Title: ERID-111328 SUBMITTAL OF THE RESPONSE TO THE NOTICE OF DISAPPROVAL FOR THE INVESTIGATION WORK PLAN FOR LOWER PAJARITO CANYON AGGREGATE AREA AND REVISION 1, INCLUDING 2 CD'S, EP2010-0521, EP2010-0522, LA-UR-10-7635

To:(Addressees - Organization) JAMES BEARZI, NMED

From:(Senders - Organization) MICHAEL J GRAHAM, LANL
 GEORGE J RAE, DOE

Figure 4.7-1 Site features of SWMU 18-003(c)

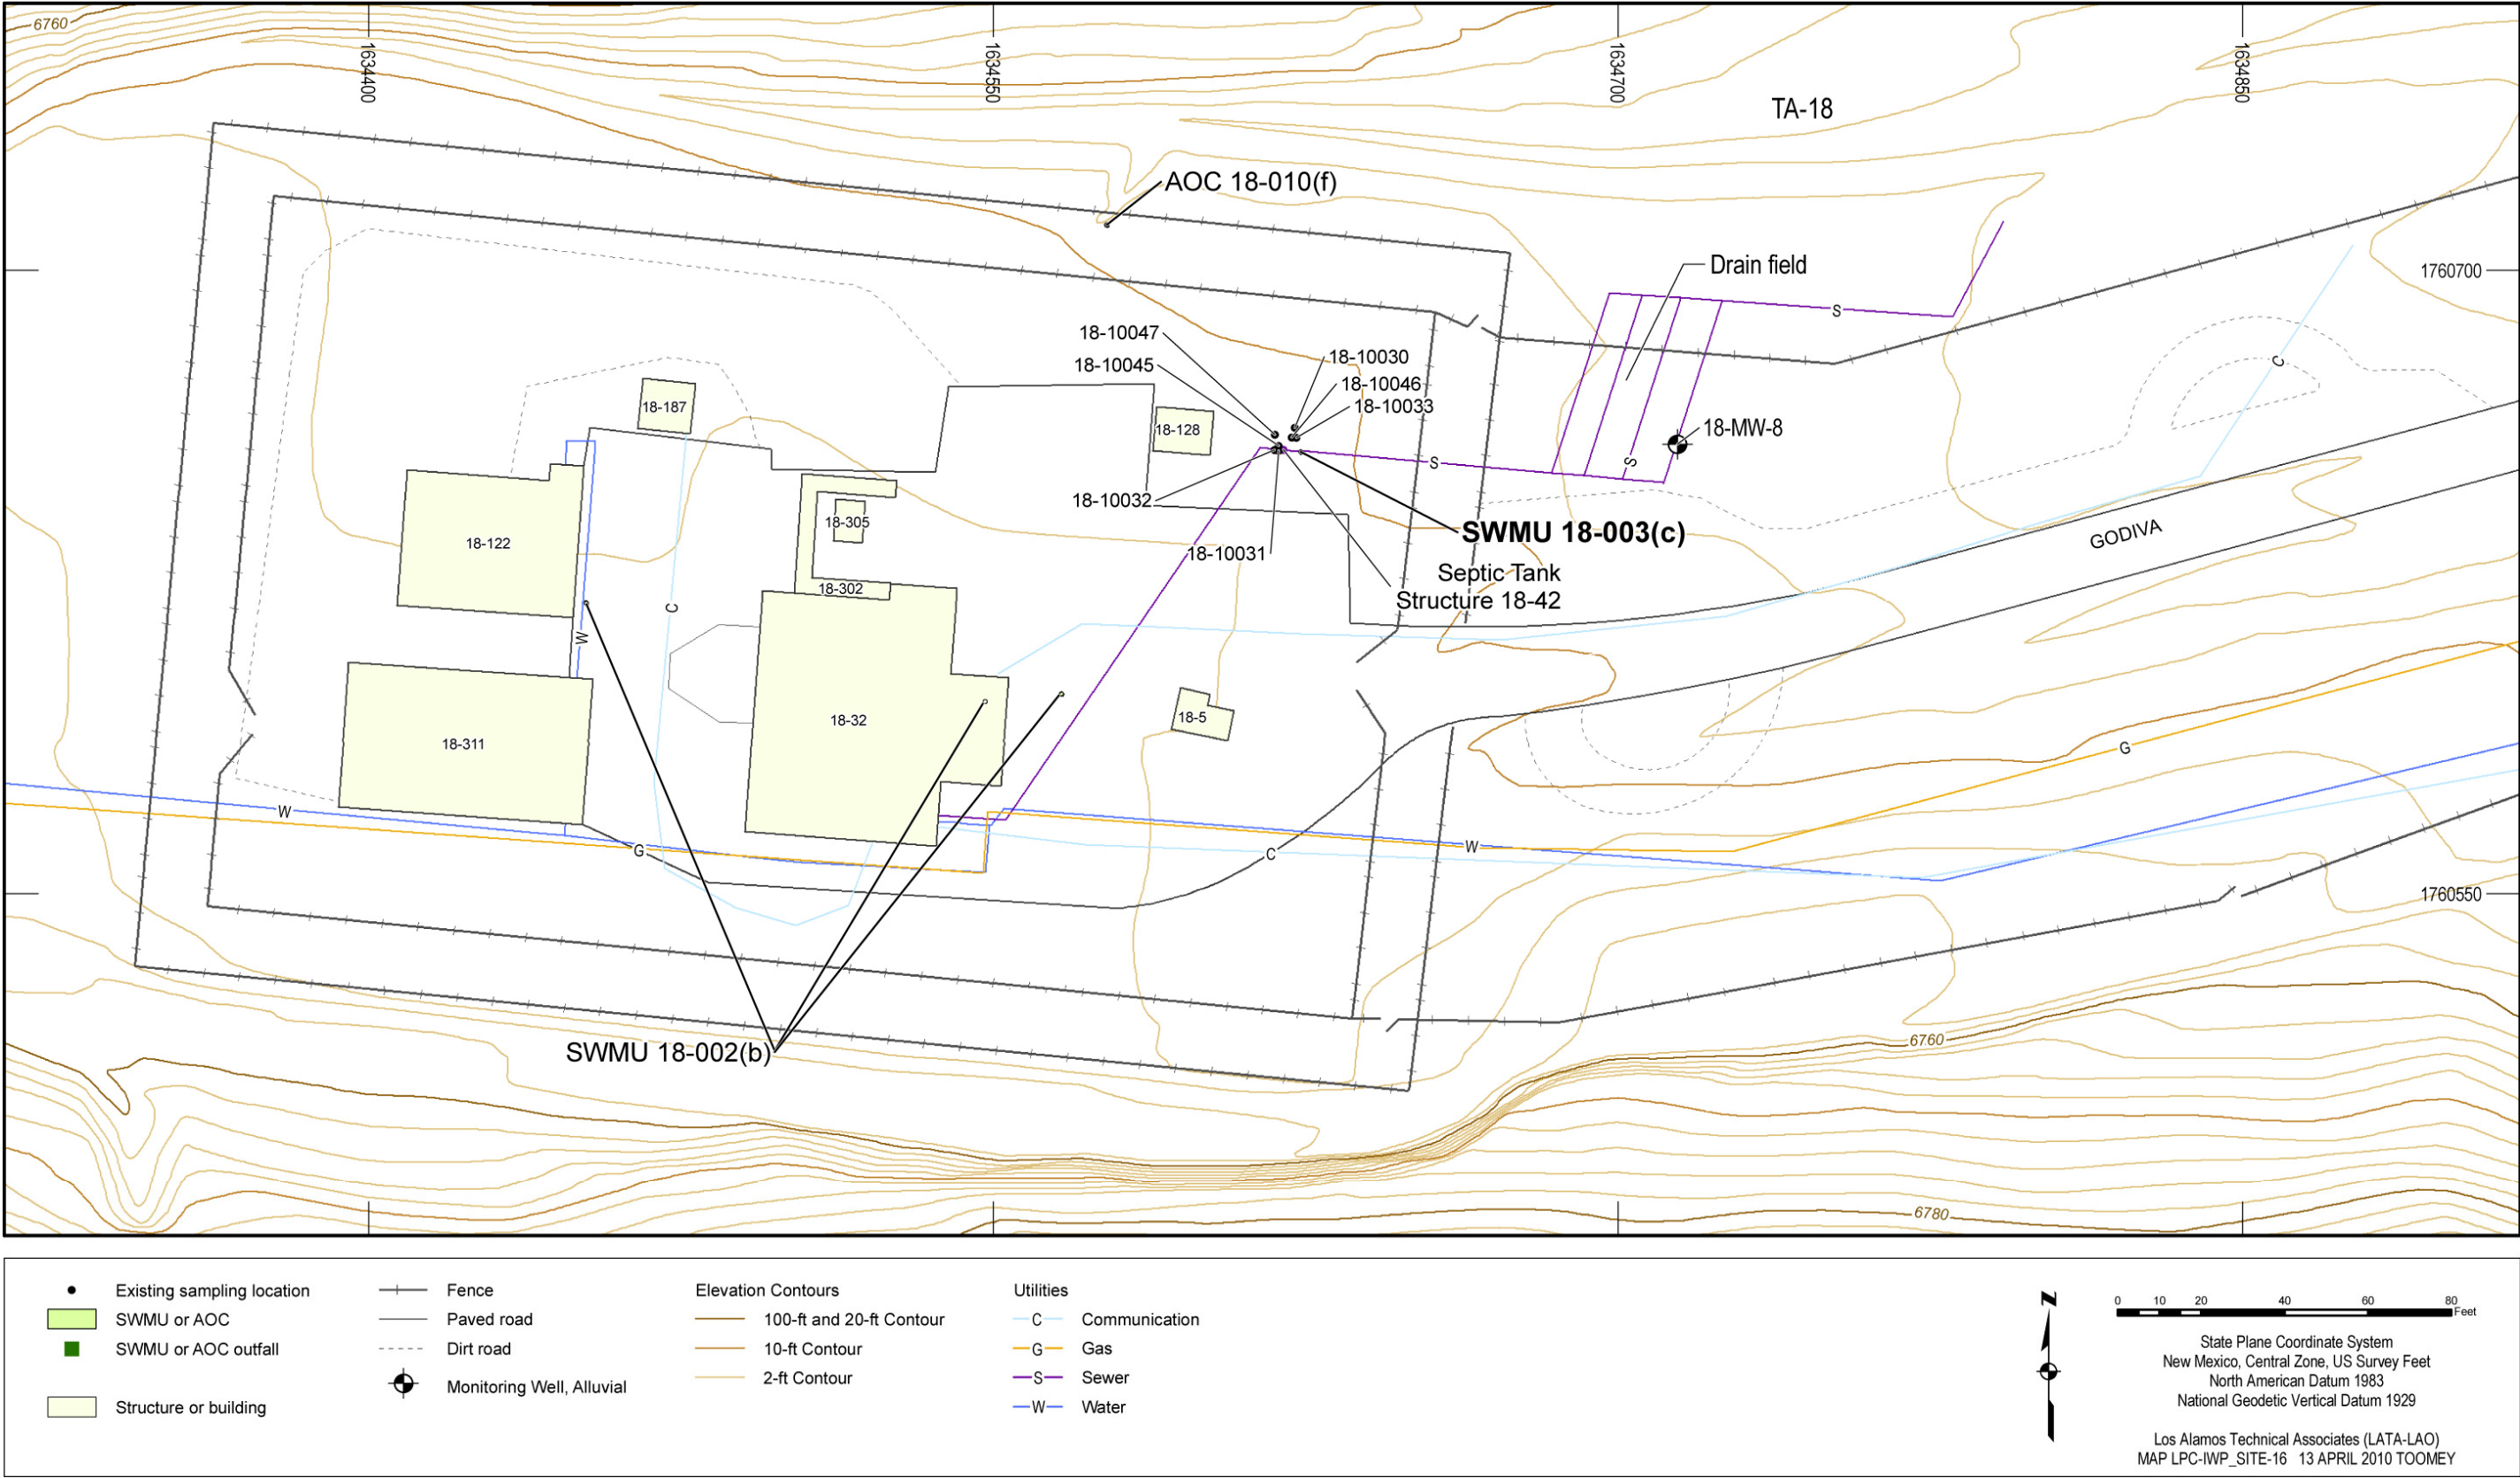
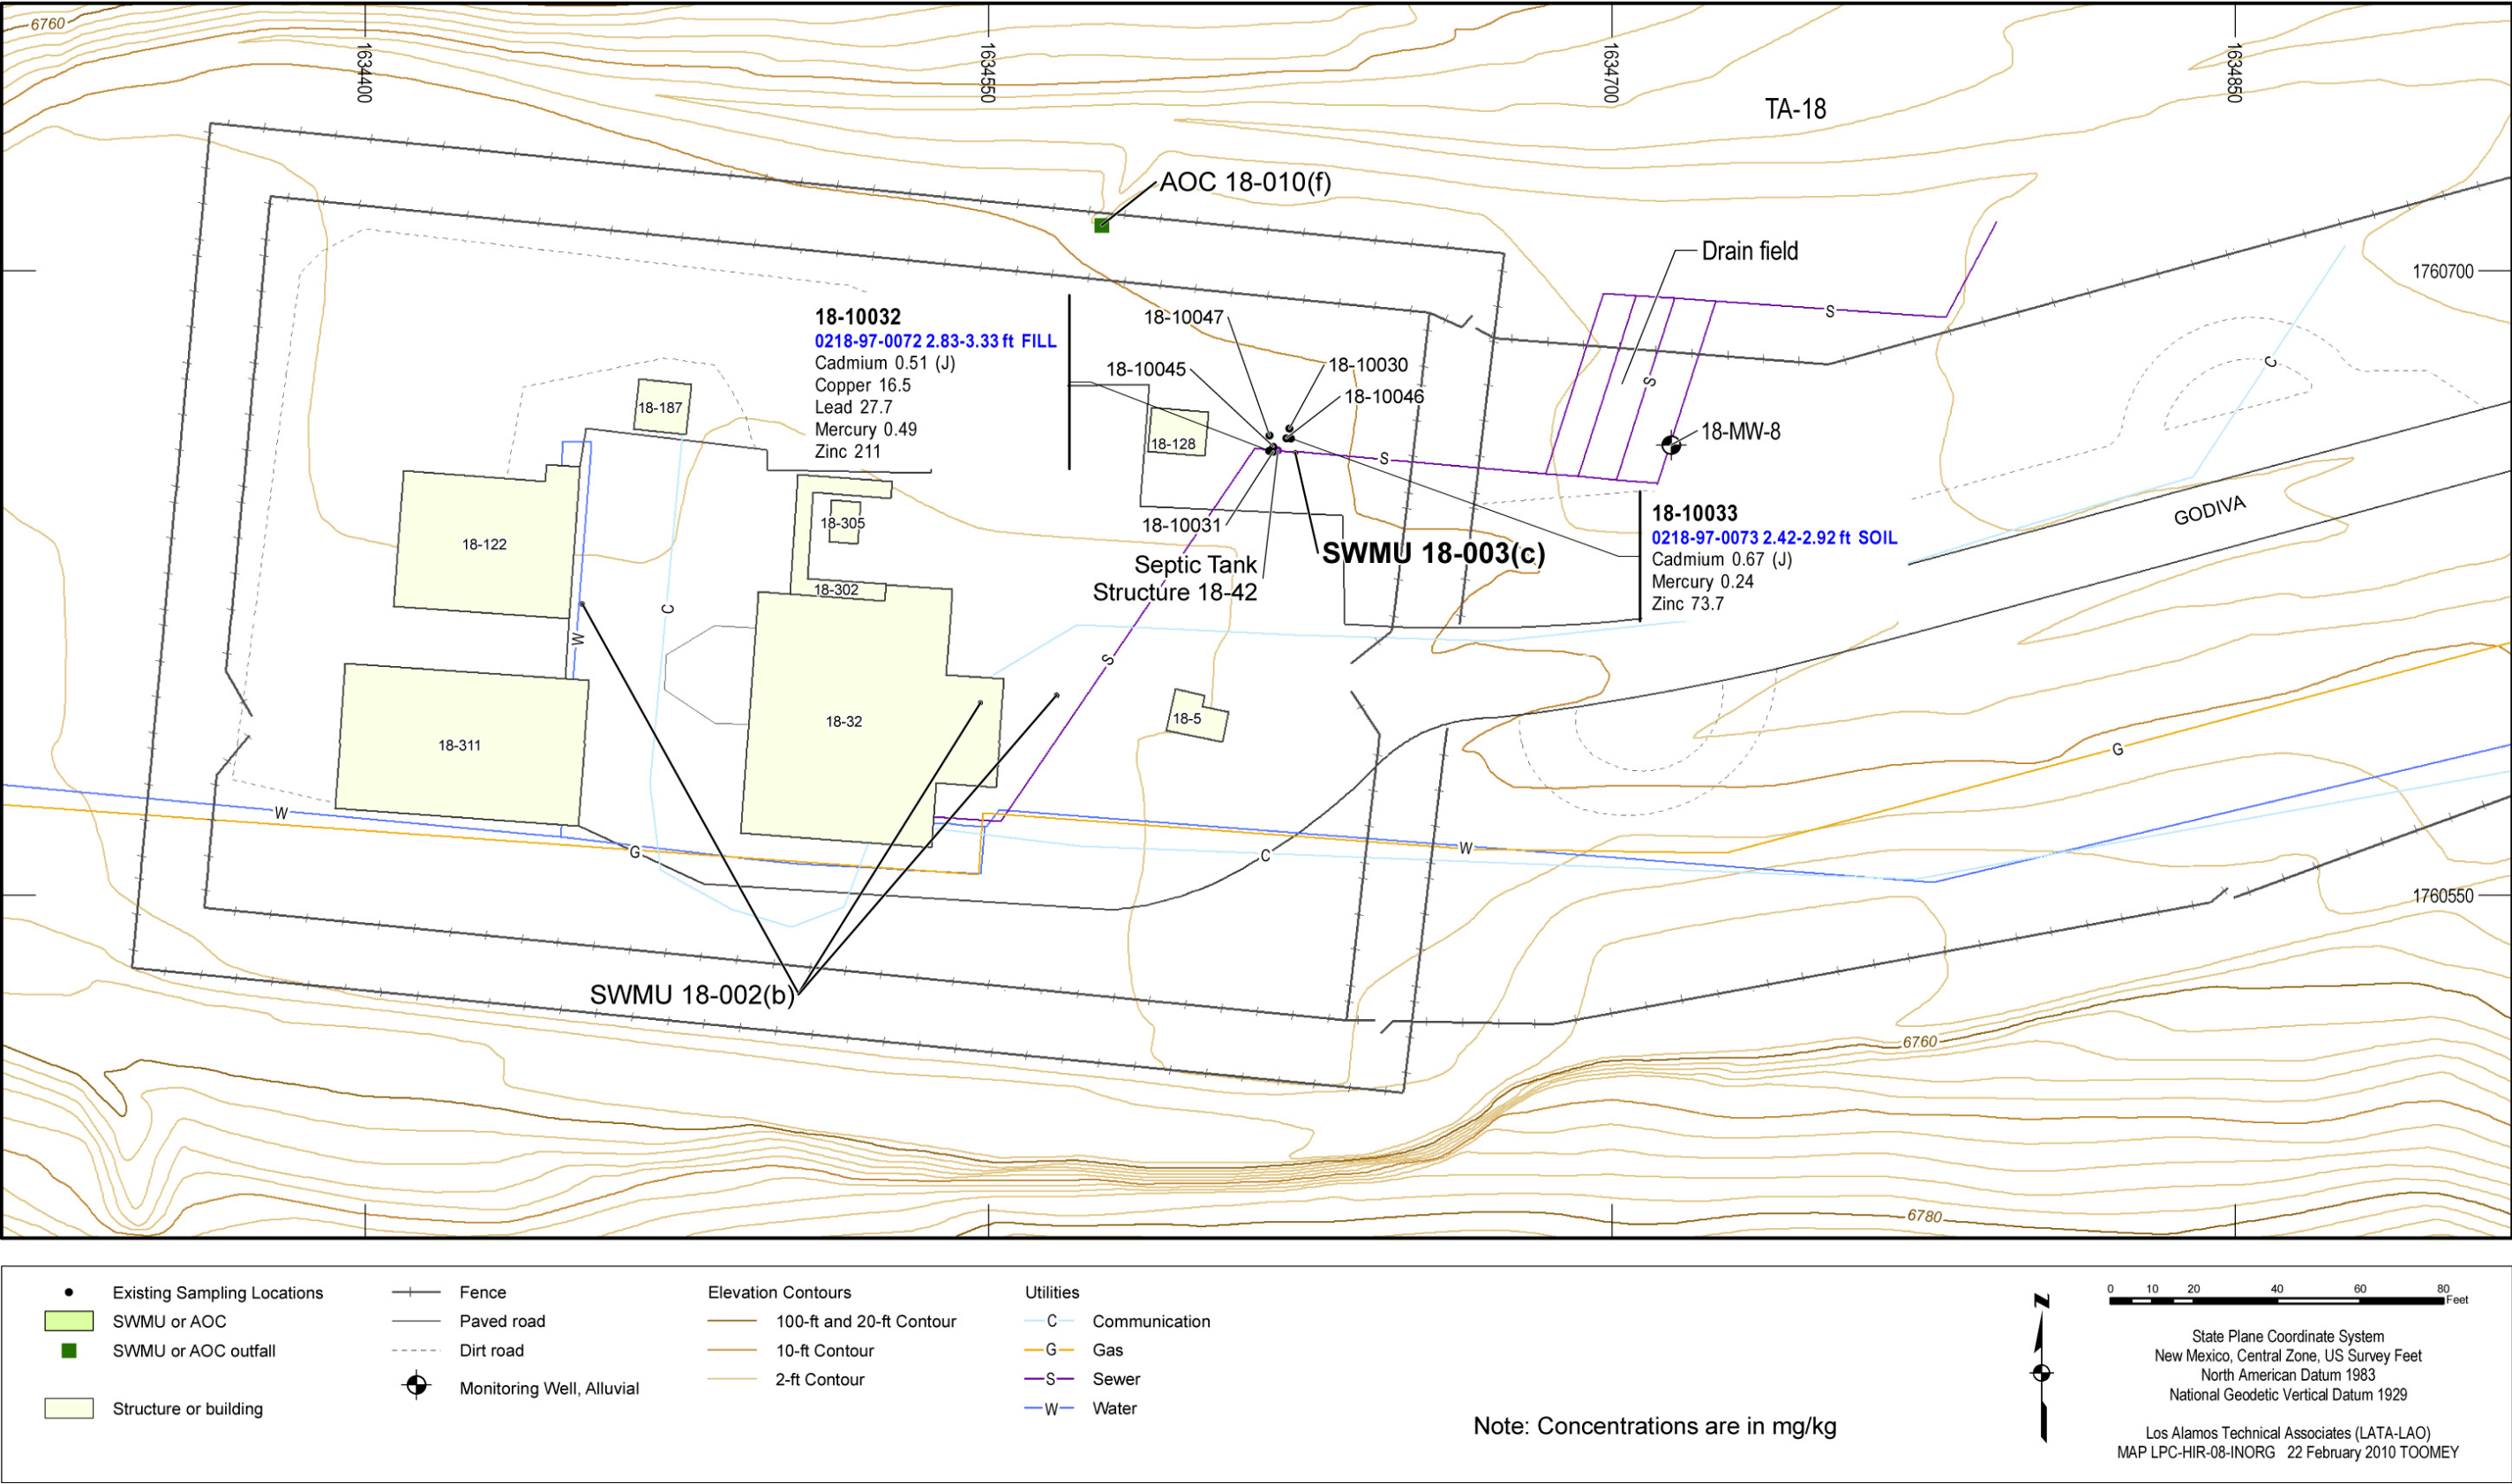
NMED Comment: Plan Plate 1 depicts a well located near SWMU 18-003(c). The well is identified as 18-MW-8 on Plate 1. Verify that well M-8 is the same well as 18-MW-8. Show the well location on

Figures 4.7-1 through 4.7-5, inclusive. According to Table 5.4-1 of the 2010 Interim Facility-Wide Groundwater Monitoring Plan, well 18-MW-8 is an alluvial well that is sampled annually for Target Analyte List (TAL) metals, volatile and semi-volatile organic compounds including tentatively identified compounds (VOCs, SVOCs and TICs, respectively), explosive compounds, radionuclides, several general inorganic analytes, perchlorate and various field indicator parameters. NMED internal correspondence indicates the well was scheduled for sampling in August 2010. If well 18-MW-8 is sampled in 2011, the Permittees must include that analytical data in the IR.

9. The text has been revised (section 4.7.1) to refer to well M-8 as well 18-MW-8, the current Laboratory designation for the well. Figures 4.7-1 through 4.7-5 have been revised to show the well as well 18-MW-8.

- 10. Section 4.7.3, Scope of Activities SWMU 18-003(c), second and third paragraphs, pages 24 and 25, Figure 4.7-3, page 86, Figure 4.7-5, page 88, and Tables 4.7-1 and 4.7-3, pages 148 and 149:**

Although the text indicates that locations chosen for sampling will be placed to coincide with the expected locations of pipe joints, review of Figure 4.7-5 indicates no sample locations have been proposed where the drain line exits Building 18-32, at the 45 degree bend located approximately 20 feet east of the building, or at the 45 degree bend located approximately 15 feet east of Building 18-128. The Permittees must either propose additional sample locations to evaluate the pipe joints or consider adjusting currently proposed locations to evaluate the joint locations.

The text in section 4.7.3, Figure 4.7-5, and Table 4.7-5 have been revised to include three additional proposed sampling locations. One location has been added where the drainline exits building 18-32; one location has been added at the 45-degree bend approximately 20 ft east of the building; and one location has been added at the 45-degree bend approximately 15 ft east of building 18-128.
